## **TECHNICAL SERVICE BULLETIN**

**Bulletin Number:** DC-2171

**Affected Model(s):** 84803, 84804, and 94804 Air Motors and Associated PM III Pump Assemblies

**Subject:** 241789 Adapter Failures

**MODELS 84803 and 84804**

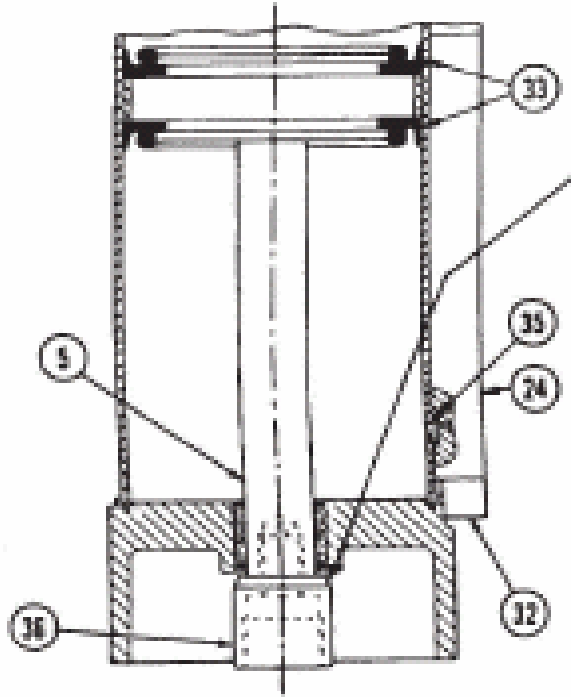
Extensive research of the issue by our Quality Assurance and Engineering departments was under taken, and the mutually agreed upon reason for the failures was the lack of recommended Loctite on the male threads that screw into the air motor piston rod assembly. Our best judgment as to what was occurring is that since little or no Loctite was applied to the adapters, they started working themselves loose. At some point, during the pushing and pulling, or up and down strokes, the adapter becomes tilted or off centered and a stress load is induced on the 241789 adapter. This slight misalignment induced on the adapter makes it the weak link between the air motor and pump tube. Due to the cyclic load on the male thread area of the adapter, the throat area of the adapter begins to crack and continues to crack until a total failure occurs.

Assembly procedures in our manufacturing facility have been reviewed and we suspect that in some cases not enough "Loctite 242 Blue" had been applied. More interesting however, is that several failed adapters have been sent in to us for inspection with little or no indication that Loctite was ever applied (factory installed or service replacements). It is imperative that service repair centers use adequate amounts of Loctite 242 on the adapter prior to screwing it into the piston rod assembly. An adequate amount would equate to 2-3 drops around the circumference of the male stud on the adapter. **PLEASE NOTE: There are no recommended torque specifications for tightening the air motor to the pump tube. Follow the instructions in Service Page A50-78.**

During any service repair of the air motor/pump tube assembly, careful attention should be paid to the notation in the service page (see attached "dotted line" depiction).

**-Assemble Adapter to Piston Rod  
-Use Loctite 242 Blue on threads.  
-Torque to 60-65 Ft. Lbs.**
